MONTGOMERY COUNTY HISTORIC PRESERVATION COMMISSION
STAFF REPORT

Address:	7100 Sycamore Ave., Takoma Park	Meeting Date:	1/5/2022
Resource:	Contributing Resource Takoma Park Historic District	Report Date:	12/29/2021
Applicant:	Marc Pfeuffer	Public Notice:	12/22/2021
Review:	HAWP	Tax Credit:	n/a
Permit No.:	973888 REVISION	Staff:	Dan Bruechert
Proposal:	Front Porch Alteration

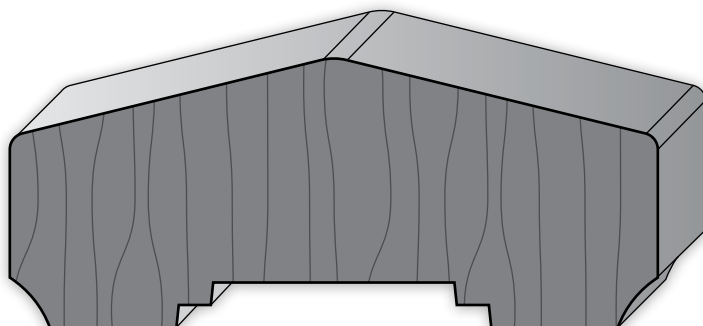
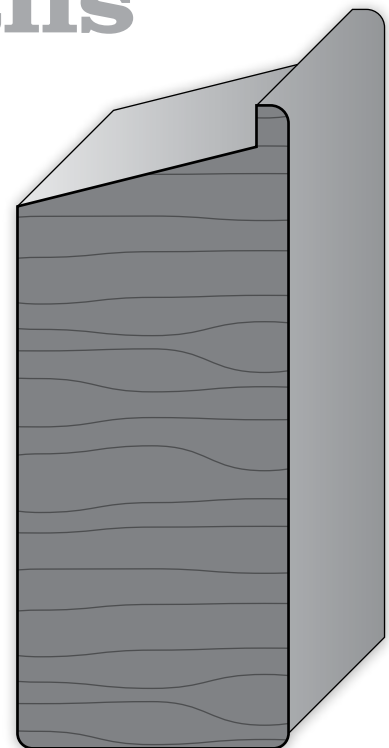
Page A9 of the drawings submitted with our HAWP application include Note A30, which specifies "New Railing - WM-8840 1-1/2 x 3-1/2 Top Rail - WM-8841 1-1/2 x 3-1/2 Bottom Rail and 1-1/4" Square Balusters - Painted White Semi-Gloss". These are standard WOOD profiles - a cut sheet for these wood rails and balusters was included in our submission and appears in page 17 of the report. To clarify, we DO NOT propose to install the Pressure Treated Wood and Square Aluminum Baluster system for the Front Porch.

A9

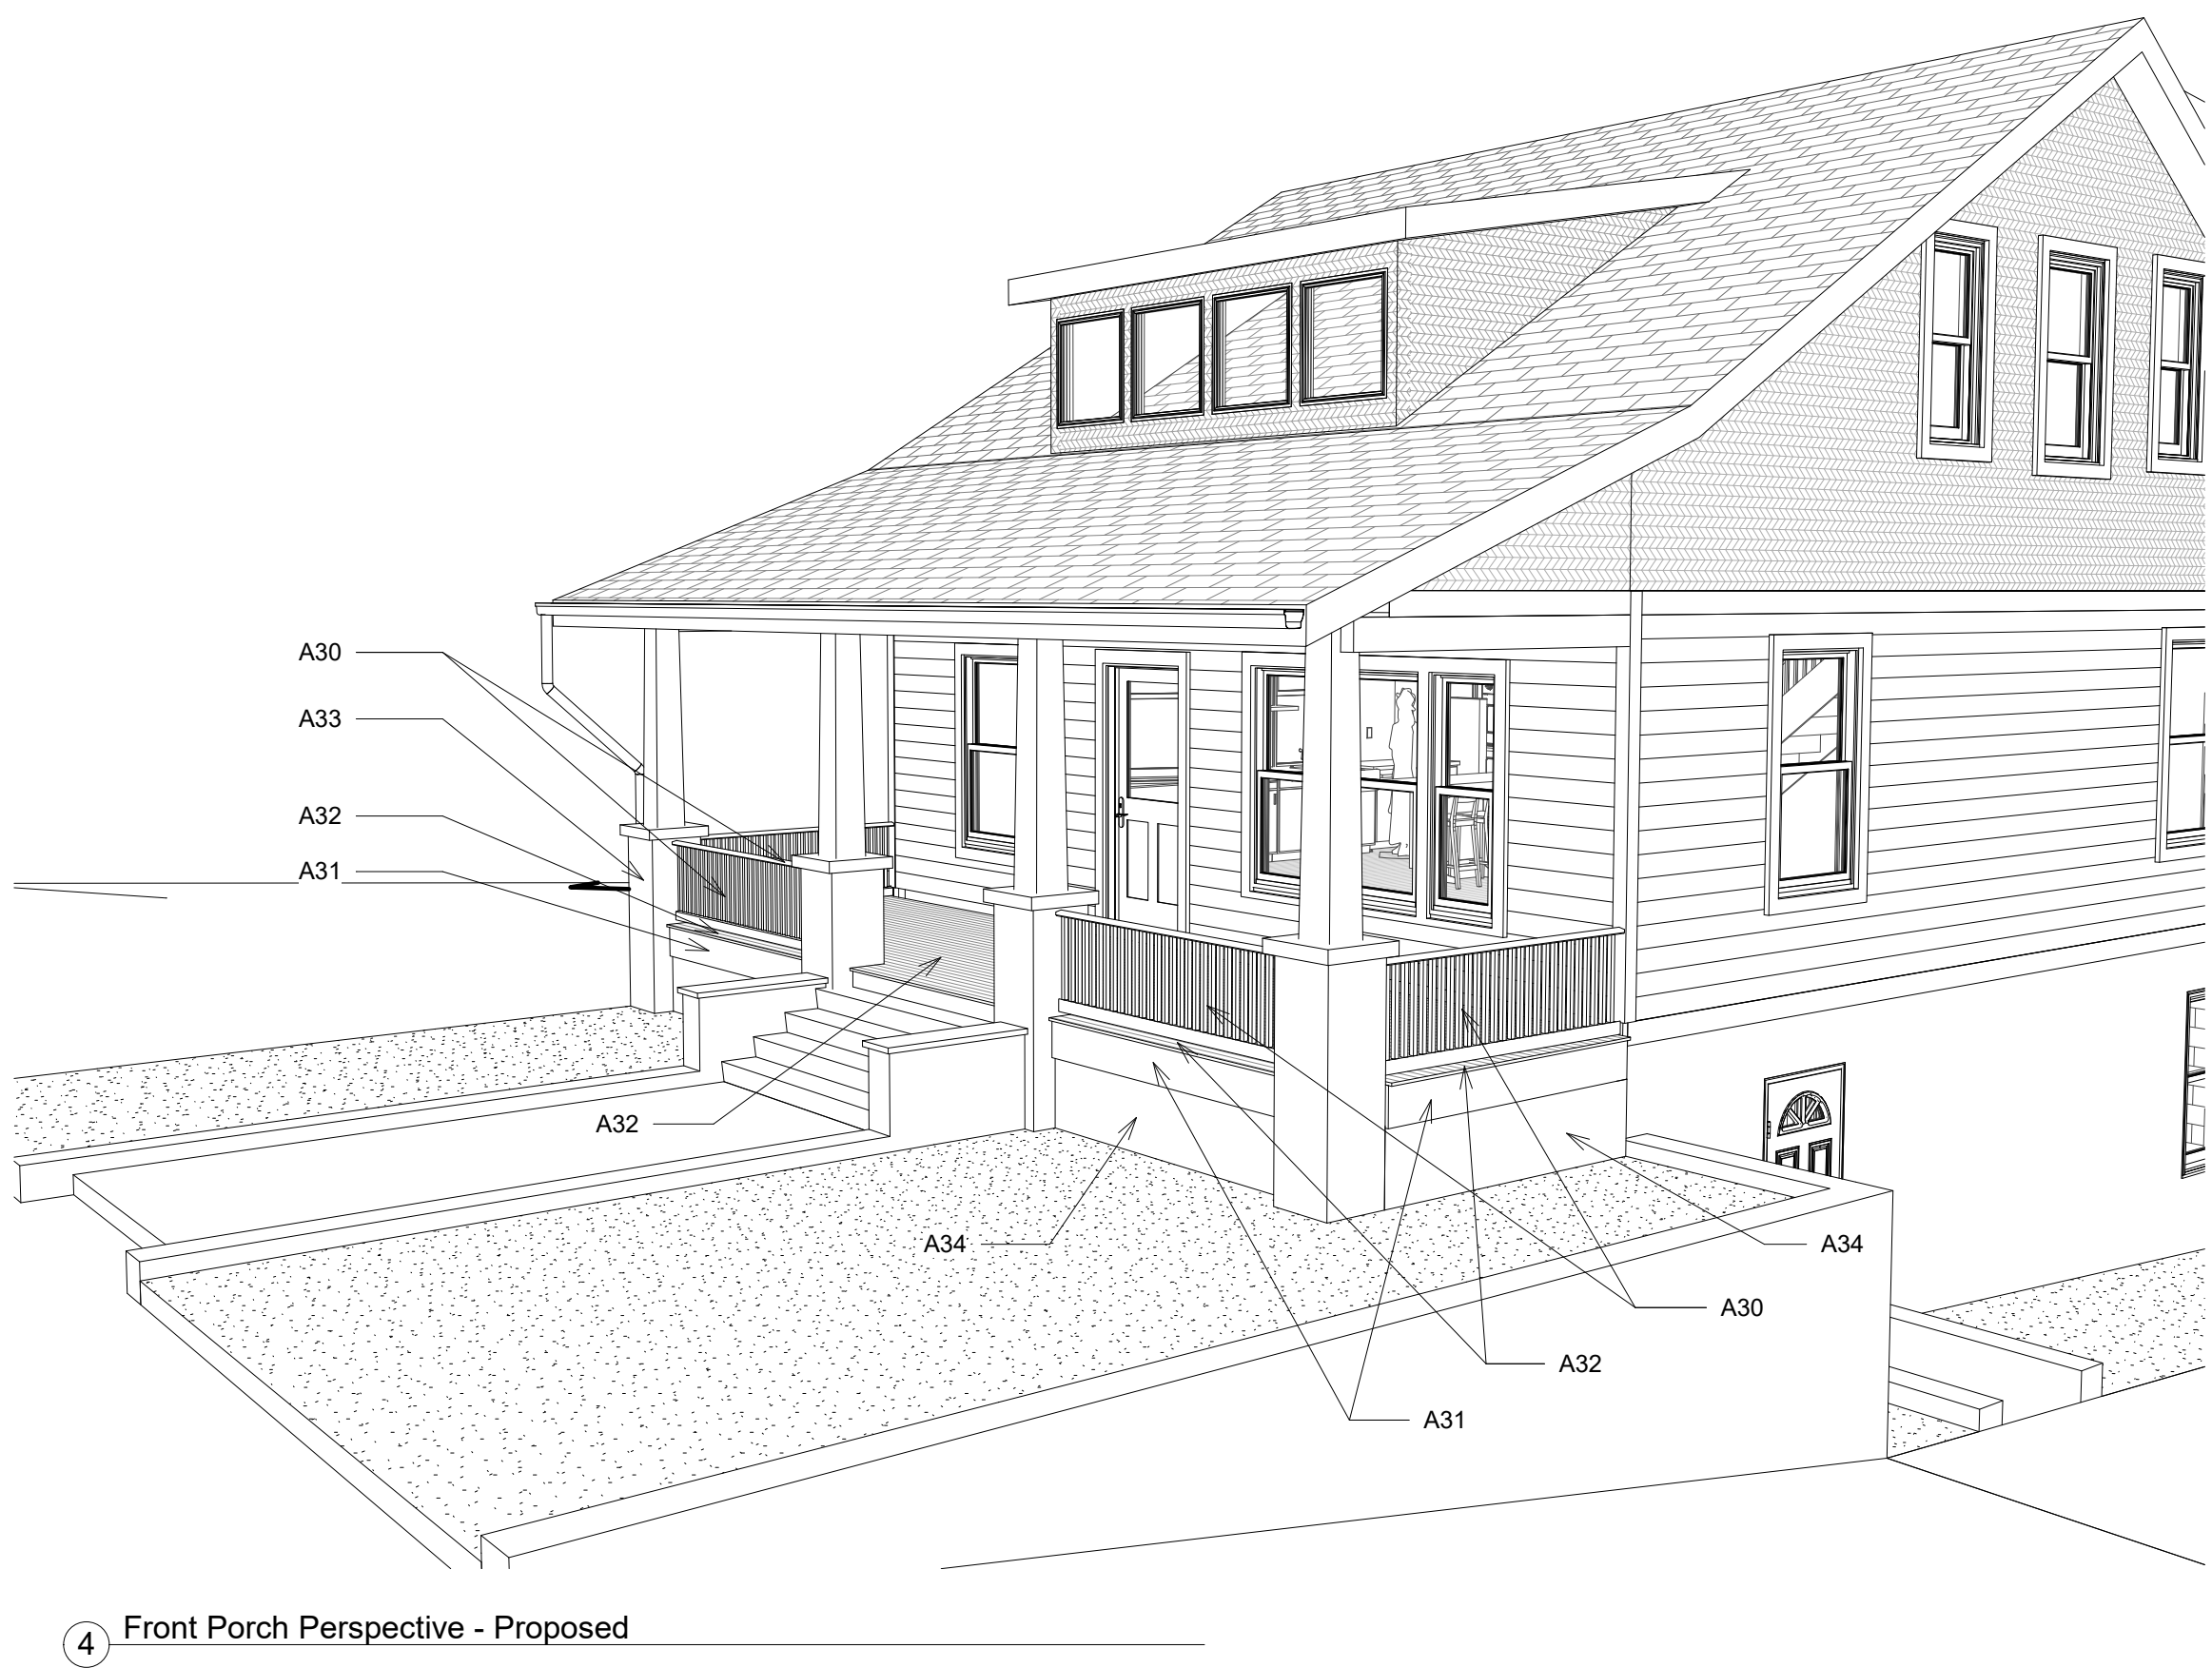
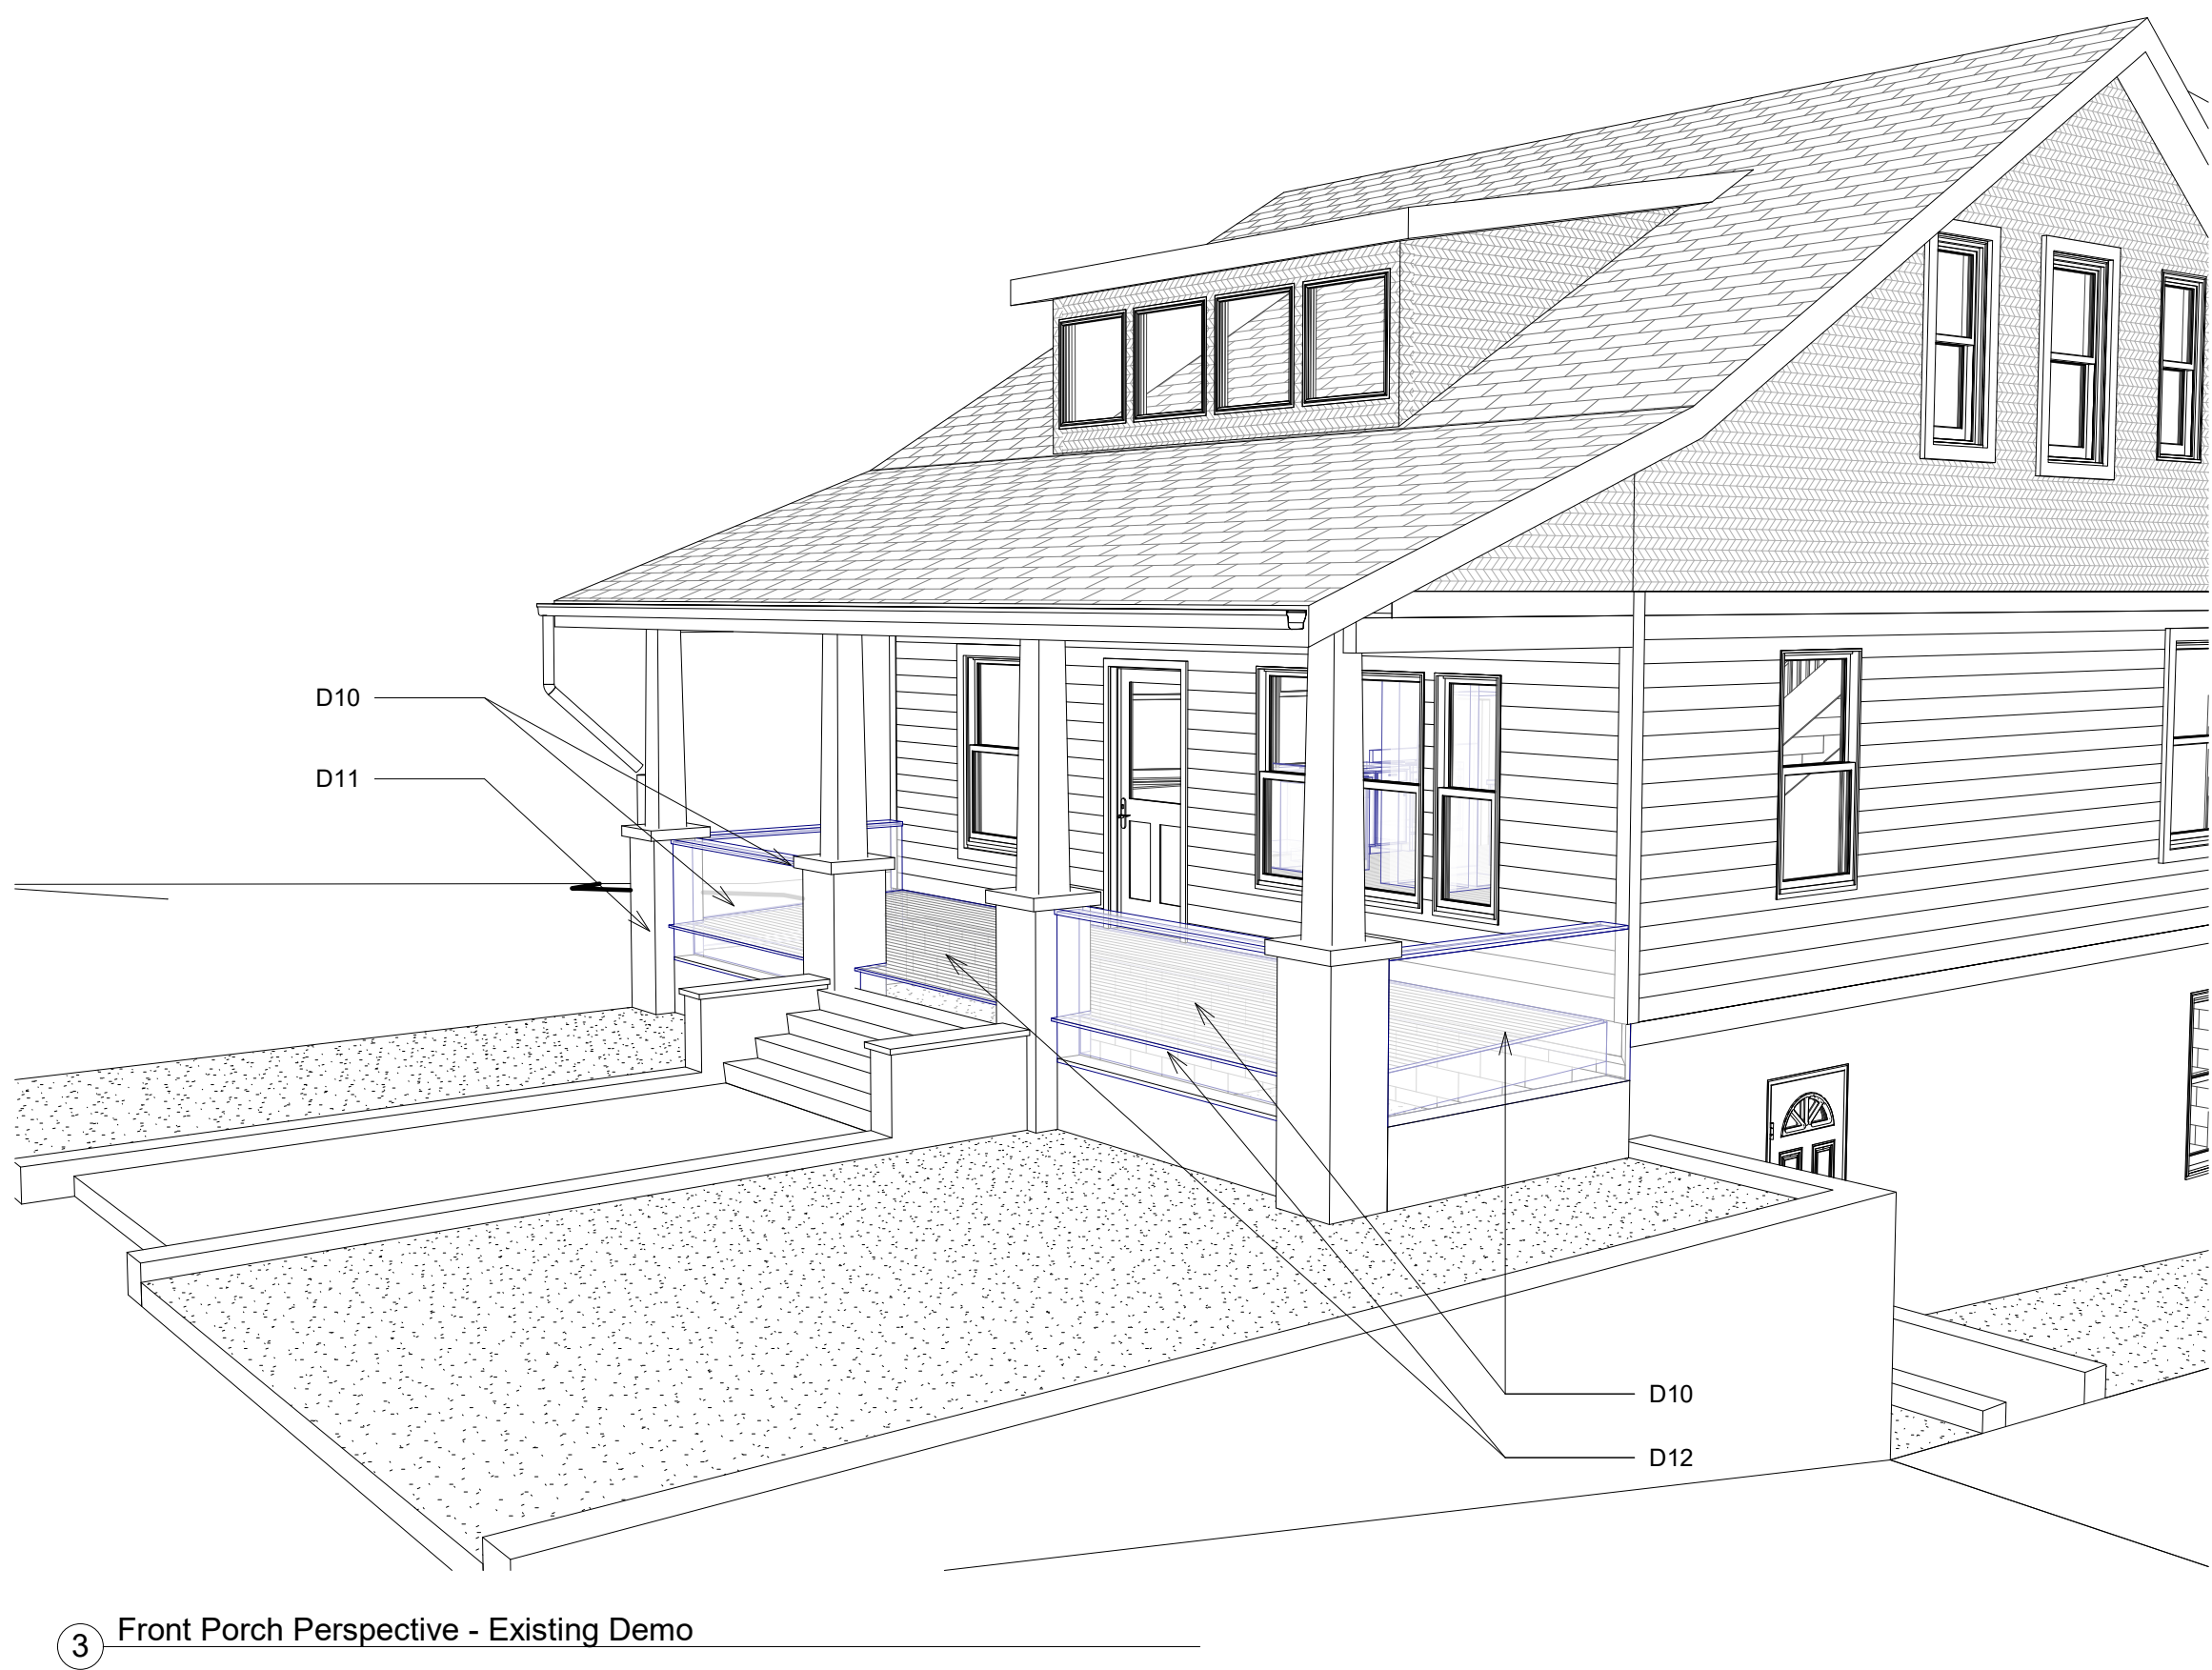
The applicant proposes removing the existing parged CMU knee wall/railing on the front porch and installing a new wood railing in its place. At a minimum, the left side of the existing railing will be demolished as part of the left column demolition and reconstruction.

The previous Staff Report stated the applicant proposed a pressure-treated wood railing with aluminum balusters. The Staff Report found that railing was incompatible with the house and surrounding district

and recommended a condition that the knee wall/railing needed to be reconstructed to its existing appearance. That information was incorrect. The railing the applicant proposes to install is a wood, painted railing. The proposed railing includes a 1 ½" × 3 ½" (one and a half inches by three and a half inches top and bottom rail with 1 ¼" (one and one-quarter inch) balusters set between the top and bottom rails.

Recognizing at a minimum half of the existing knee wall will have to be demolished as part of reconstructing the left-most column due to its severe lean, the question becomes what is the appropriate detail for a porch railing? Staff's preference is reconstructing the existing configuration of the knee wall as conditioned in the HAWP approval. As a replacement in-kind, this work would not require a HAWP and would be eligible for the County Historic Preservation Tax Credit (as will replacing the porch decking with wood and replacing the damaged column).

However, the applicant proposes replacing the existing knee wall with a new wood railing. Staff finds that the proposed railing is generally consistent with the *Design Guidelines* and 24A-(b)(2) and (d). First, the *Design Guidelines* for Contributing Resources state that the review should consider the impact to the overall streetscape rather than a close scrutiny of architectural features. Second, the *Design Guidelines* state that alterations to existing features should be consistent with the predominant style of the resource and that “exact replication of existing details and features is... not required.” Additionally, Staff finds that while the new railing is a change in design, a wood railing still respects the Craftsman style of the house as required by the *Design Guidelines*. Staff finds that wood railings are common on Craftsman houses from high-style to vernacular.

Staff finds that while the proposal appears to conflict with Standard 6, it is consistent with the *Design Guidelines*; and that where there is a conflict between the Standards and locally-adopted guidance, the local guidance takes precedence. Staff additionally finds that the proposed wood railing is compatible, under a lenient level of review, with the Craftsman style of the subject property per 24A-8(b)(2) and 24A-8(d).

Staff recommends that the Commission **approve** the HAWP application; under the Criteria for Issuance in Chapter 24A-8(b)(2) and (d) of the *Takoma Park Historic District Guidelines*, having found that the proposal will not substantially alter the exterior features of the historic resource and is compatible in character with the district and the purposes of Chapter 24A;
